LOWER MINNESOTA RIVER WATERSHED DISTRICT

Item 6. B. - Metro Pond Maintenance Group A2 Project (LMRWD No. 2024-021)

Technical Memorandum

Re: Metro Pond Maintenance Group A2 Project (LMRWD No. 2024-021)

Figure 2: Metro Pond Maintenance Group A2 Site 8
LMRWD No. 2024-021

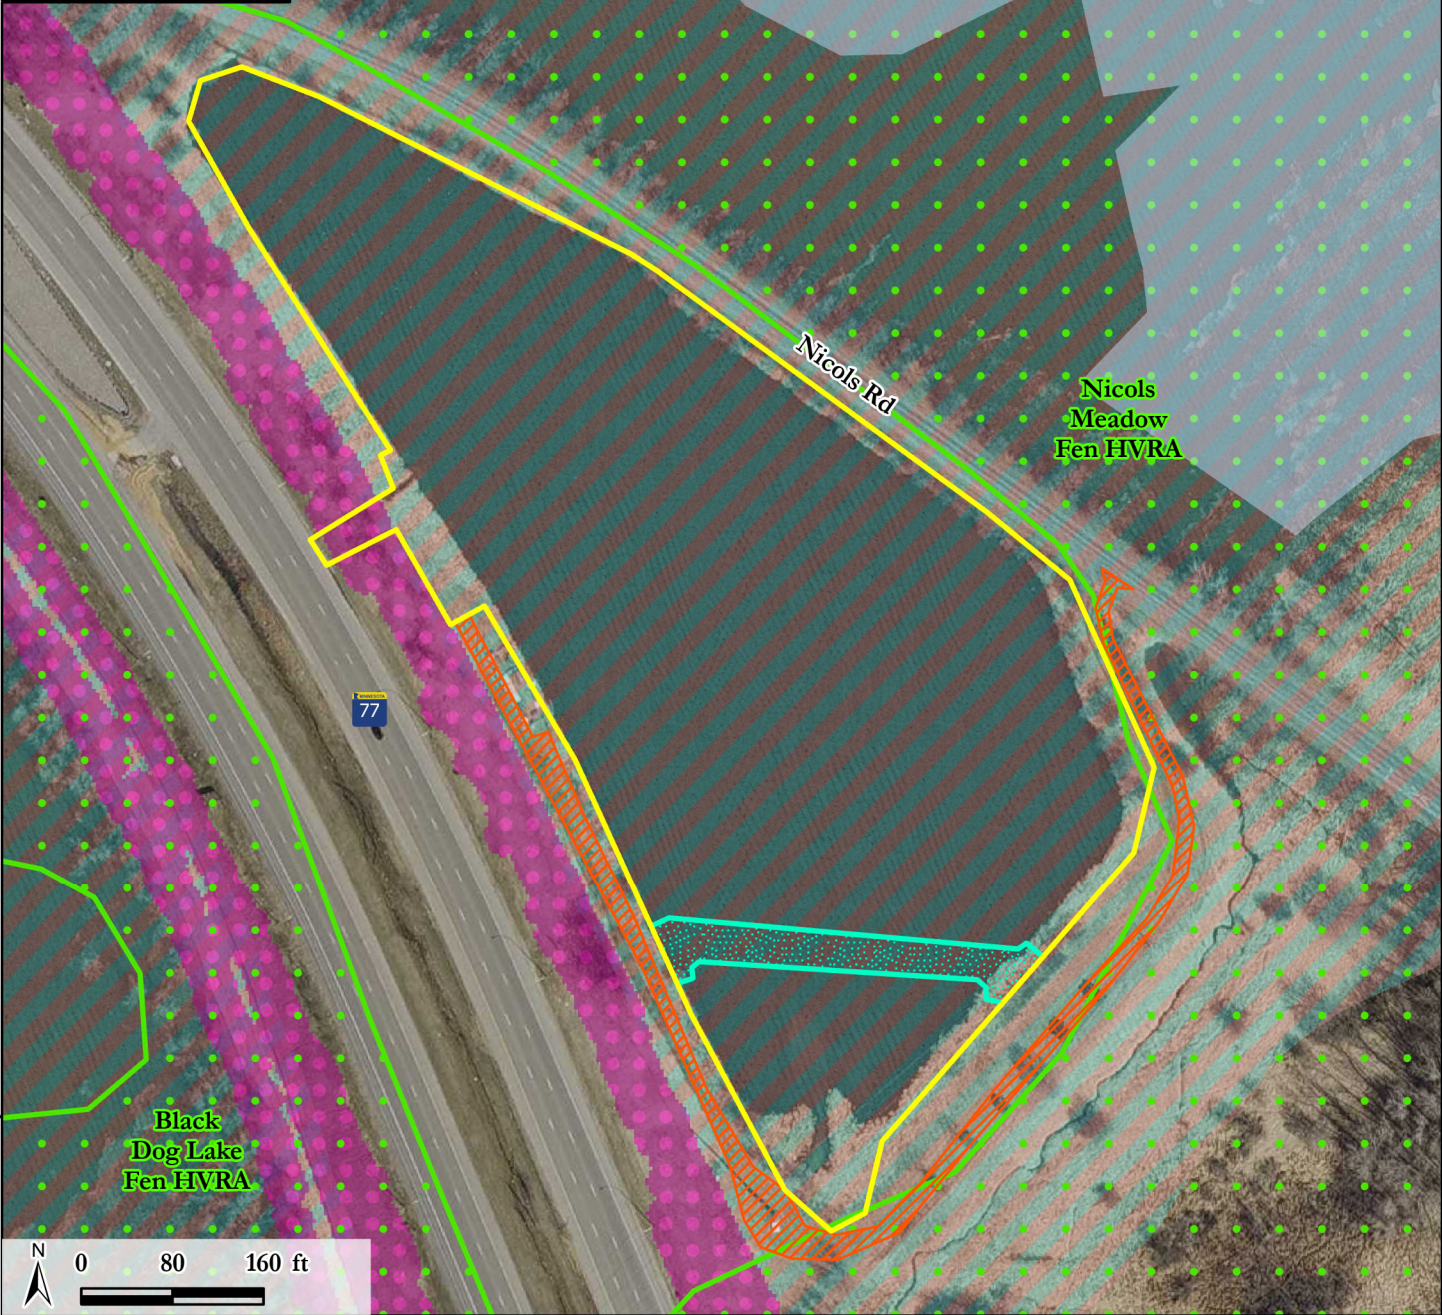
The LMRWD requires documentation that any proposed floodplain fill will not cause an increase in 100-year water surface elevations. Site 8 and Site 9 are located within the Minnesota River 100-year floodplain, per Flood Insurance Rate Map (FIRM) Panel 27037C0080E (effective December 2, 2011) and Figures 2 and 3.

The project proposes 95 cubic yards of cut and 642 cubic yards of fill, resulting in 547 cubic yards of net fill between the normal water level and the 100-year water surface elevation of the Minnesota River. The work at Site 8 includes installation of a spillway berm and slope restoration resulting in 61 cubic yards of cut and 48 cubic yards of fill (net cut of 13 cubic yards). The work at Site 9 includes berm restoration resulting in 34 cubic yards of cut and 594 cubic yards of fill (net fill of 560 cubic yards). The work at Site 9 does not include compensatory storage.
